SUNDRY NOTICES AND REPORTS ON WELLS
Do not use this form for proposals to drill or to re-enter an abandoned well. Use form 3160-3 (APD) for such proposals.

Well: **WTU 945**

Current Wellbore Diagram

**Permanent Abandonment of Federal Wells
Conditions of Approval (LPC Habitat)**

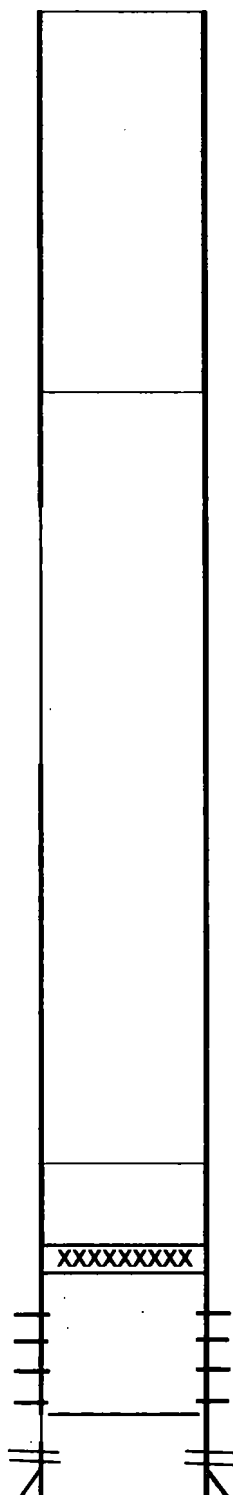
Surface Csg: 8.625" J 55 32#
Set: 1328' **1312**
Hole Size: 12.25"
Circ: Yes
TOC: Surface
TOC By: Circ ✓

Formation Name	TD, ft	
	Top	
Rustler	1300'	1289
Salt	1400'	1412
Base salt	2910'	2920
Tansil	2950'	
Yates	3080'	3082
Seven Rivers	3305'	2295

Prod Csg: 5.5" J55 15.5#
Set: 3359' **3360**
Hole Size: 7.875"
Circ: yes
TOC: surface
TOC By: circ ✓

Yates Squeezed: 3318-3322' ✓
